AGENDA

ARCHITECTURAL REVIEW BOARD MEETING
CITY HALL, 385 SOUTH GOLIAD STREET, ROCKWALL, TEXAS
APRIL 29, 2025 IN THE CITY COUNCIL CONFERENCE ROOM AT 5:00 PM

PROJECT COMMENTS

PROJECT NUMBER: SP2025-014
PROJECT NAME: Site Plan for a Retail/Office Building
SITE ADDRESS/LOCATIONS: 2351 HARBOR HEIGHTS DR

ELECTRICAL LIGHTING

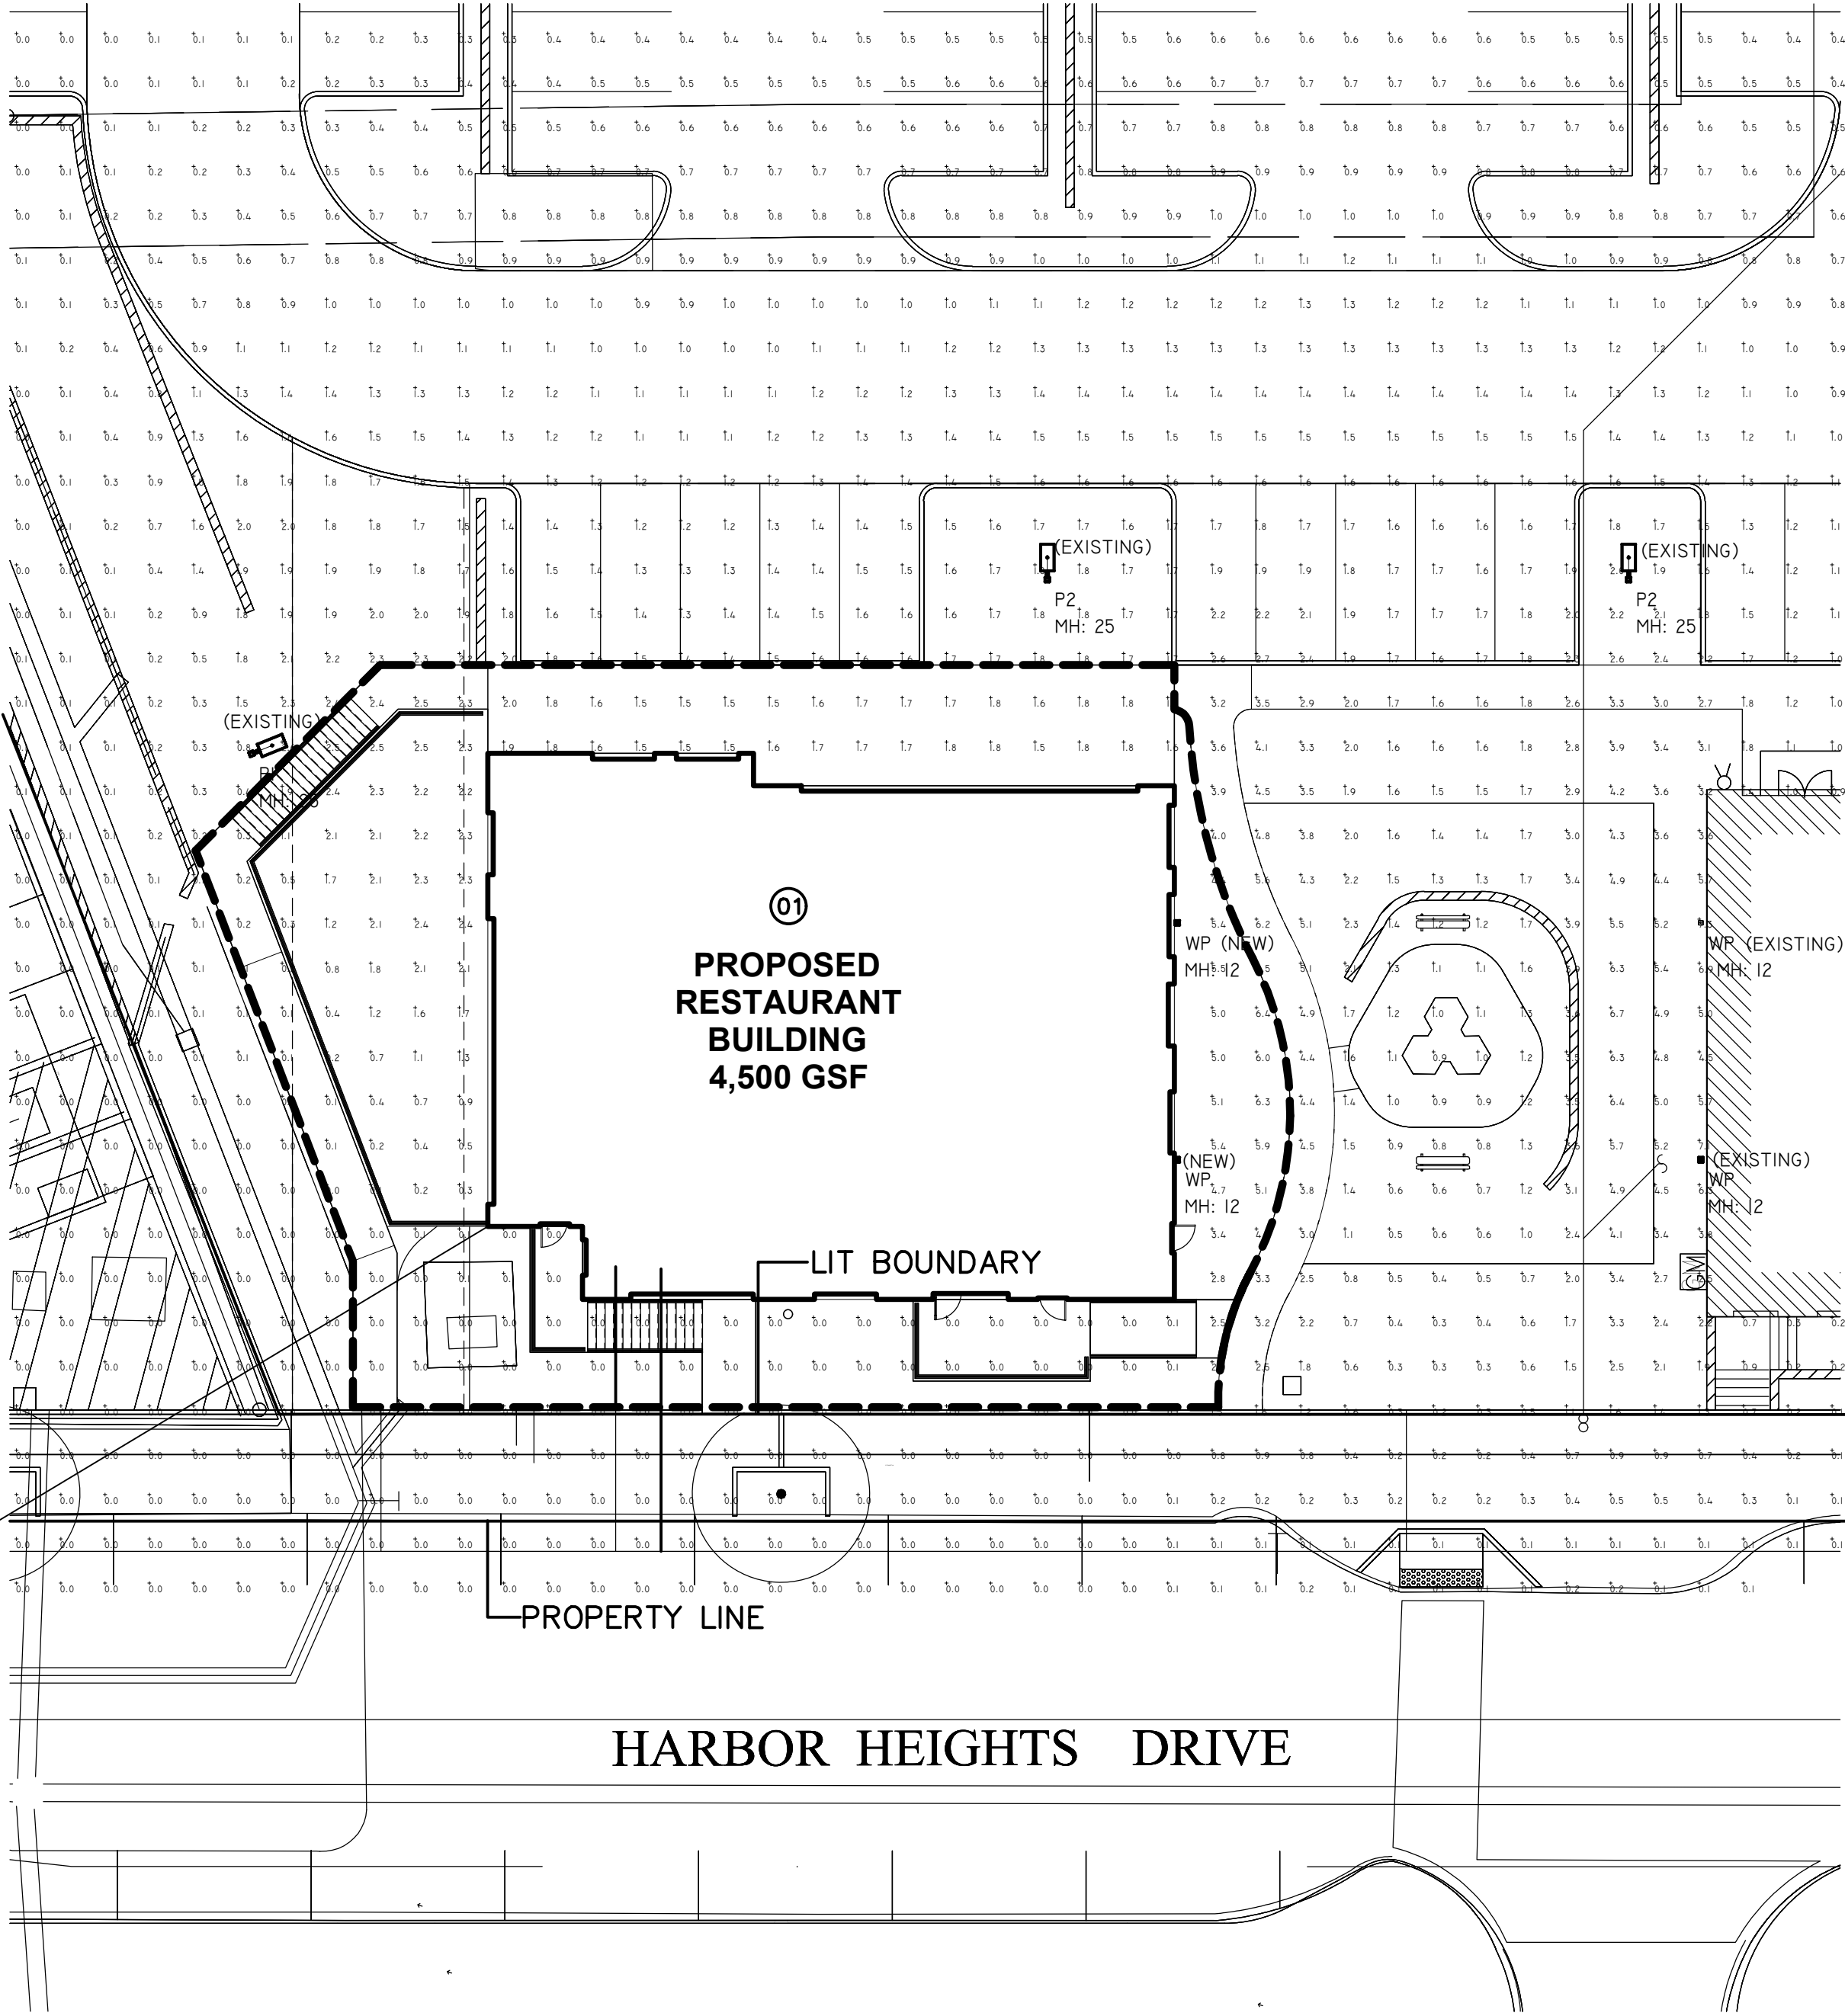
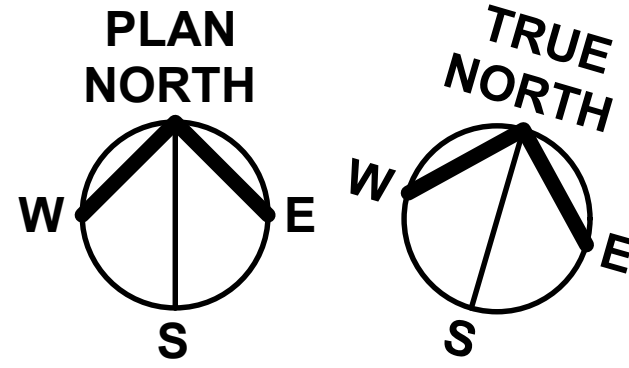
(2) Please provide lighting cut sheets that indicate the wattage for each exterior lighting fixture. Light sources (e.g. light bulbs) shall be oriented down and toward the center of the site or shielded so as to not be visible from the property line. (Subsection 03.03.A, of Article 07, of the UDC)

3 NORTH (SPRINGER LN) ELEVATION
SCALE: 1/16" = 1'-0"

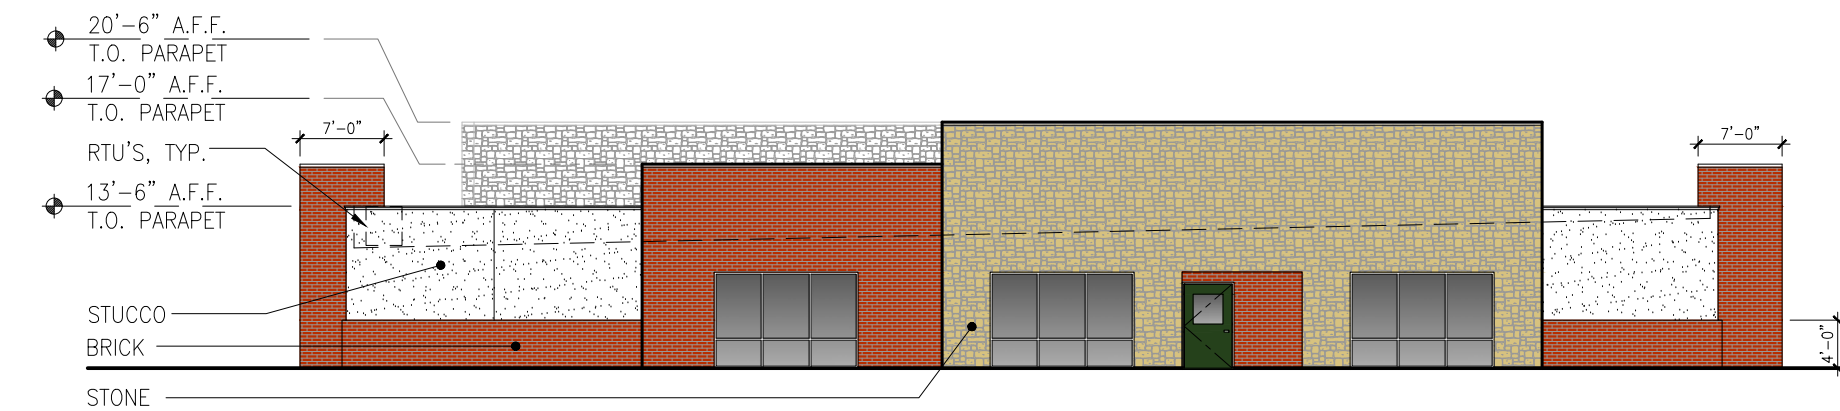
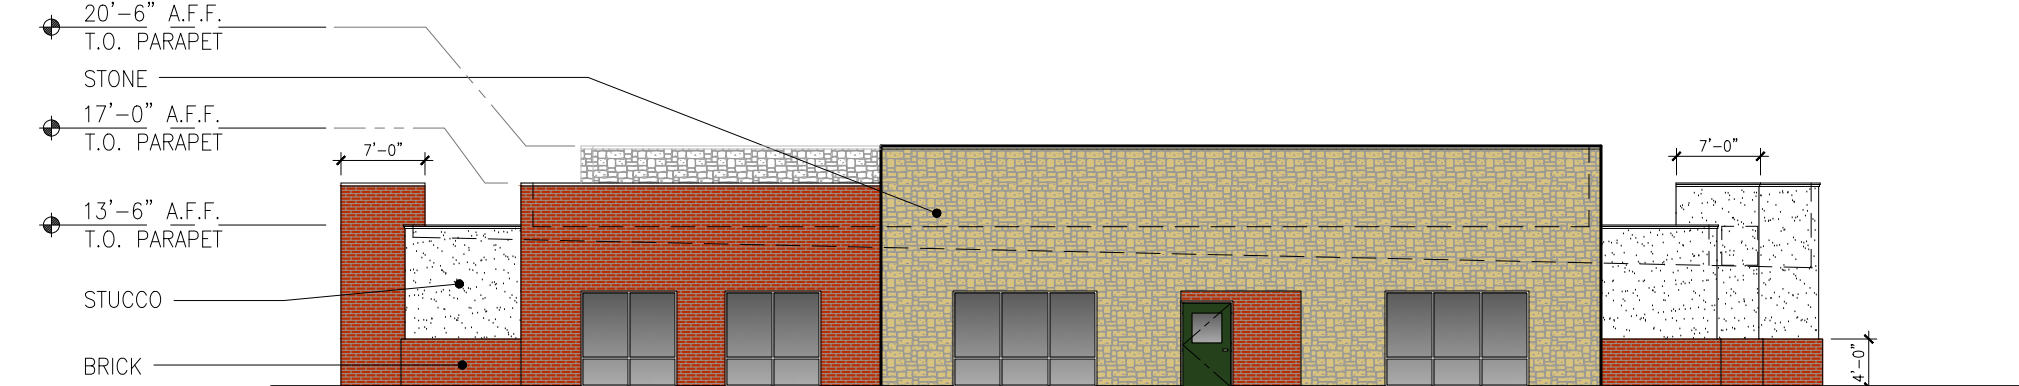
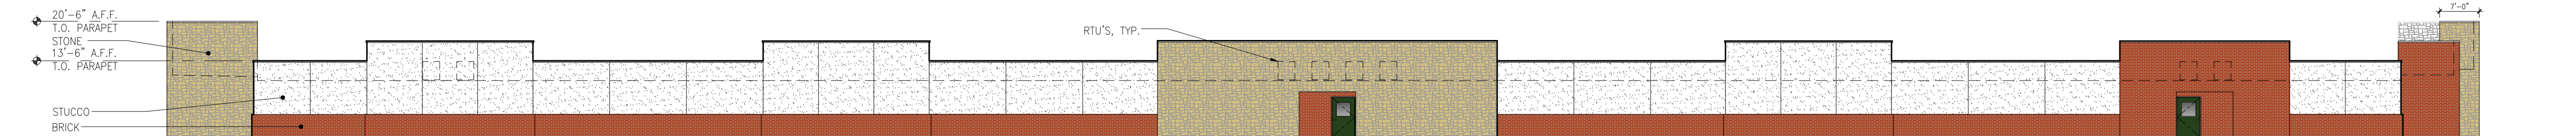
- (2) Architectural Standards. According to Subsection 06.02(C), *General Overlay District Standards*, of Article 05, *District Development Standards*, of the Unified Development Code (UDC), “(a)ll buildings shall be architecturally finished on all four (4) sides utilizing the same materials, detailing, articulation and features.” In this case, the applicant is not providing the same detailing and features (*i.e. glass storefront and windows*) on all four (4) sided. This will require a variance from the Planning and Zoning Commission.
